Access Compliance Report

Public Rights-of-Way (Curb Ramps)

Intersection ID: 10037397	Main Street: SCALEYBARK_RD	Cross Street: N/A	Location: W
ADA ID: DE06BD292CC3	Ramp Type: Para	Initial Pass/Fail: Fail	Overall Compliance: No
		Severity Score: 12.5

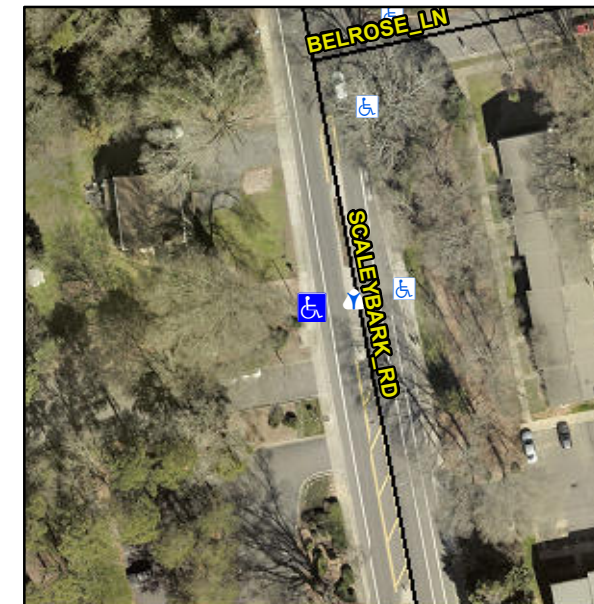
R304.3.2

Compliance	Description	Data	Compliance	Description	Data
N/A	Ramp Length LT (in)	72.0	N/A	Ramp Length RT (in)	130.0
Yes	Ramp Width LT (in)	58.5	Yes	Ramp Width RT (in)	58.5
Yes	Ramp Slope LT (%)	5.5	No	Ramp Slope RT (%)	8.4
Yes	Ramp XSlope LT (%)	1.4	Yes	Ramp XSlope RT (%)	0.8
N/A	Landing Length (in)	N/A	N/A	DWS Provided?	N/A
N/A	Landing Width (in)	N/A	N/A	DWS Contrast?	N/A
N/A	Landing Slope (%)	N/A	N/A	DWS Length (in)	N/A
N/A	Landing X Slope (%)	N/A	N/A	DWS Full Width?	N/A
N/A	Landing Curb? (Y/N)	N/A	N/A	DWS Offset (in)	N/A
N/A	Shared Landing?	N/A			
N/A	Gutter Ponding?	N/A	N/A	Gutter Slope (%)	N/A
N/A	Gutter Lip Ht (in)	N/A	N/A	Gutter X Slope (%)	N/A
N/A	Painted X Walk1?	No	N/A	Painted X Walk2?	N/A
	X Walk 1 Direction	To E		X Walk 2 Direction	N/A
N/A	X Walk 1 Width (in)	N/A	N/A	X Walk 2 Width (in)	N/A
	X Walk 1 Slope (%)	3.1		X Walk 2 Slope (%)	N/A
	X Walk 1 X Slope (%)	2.8		X Walk 2 X Slope (%)	N/A
N/A	Ramp inside XWalk1?	N/A	N/A	Ramp inside XWalk2?	N/A

Remove & Replace Entire Ramp.
